Mission Bay Development Group, LLC
401 Terry Francois Blvd.
San Francisco, CA 94158
Tel. (415) 355-6600
Fax. (415) 355-6670
April 14, 2025

Mission Bay Development Pump Station 3 Bid Documents

BID ADDENDUM 2

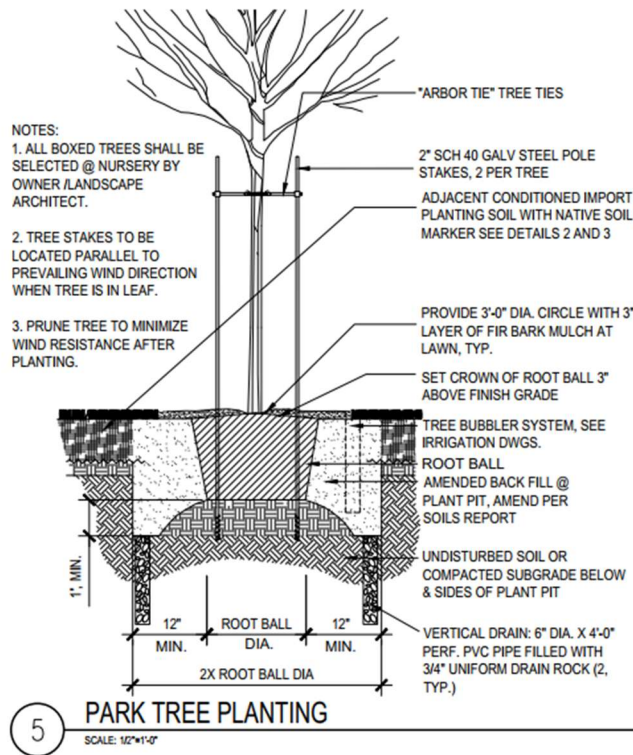
Q:80: Refer to part 2.2 of section 02906, sod type is specified as Medallion Extreme purchased from Pacific Sod. However, this vendor is permanently closed. Could you recommend for any product as an alternate?

A80: Contractor to submit an equal product from a preferred vendor for consideration.

3

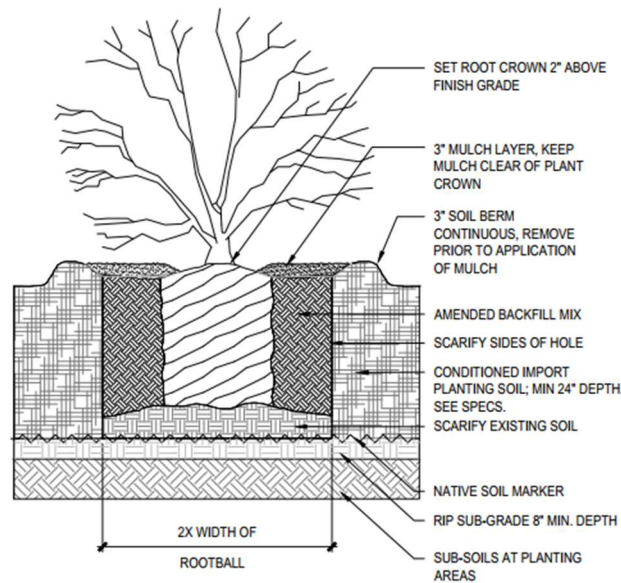
Q:82: Refer to part 3.1E of section 02910, the depth of imported topsoil to place all shrub and ground cover areas is required to be minimum 18 inch; however, it shows minimum 24" depth in detail 3 on sheet M3S-L5.02. Please clarify which depth shall be used for bidding purpose.

A82: For all shrubs, please provide minimum 24" depth as shown in detail 3 on sheet M3S-L5.02.
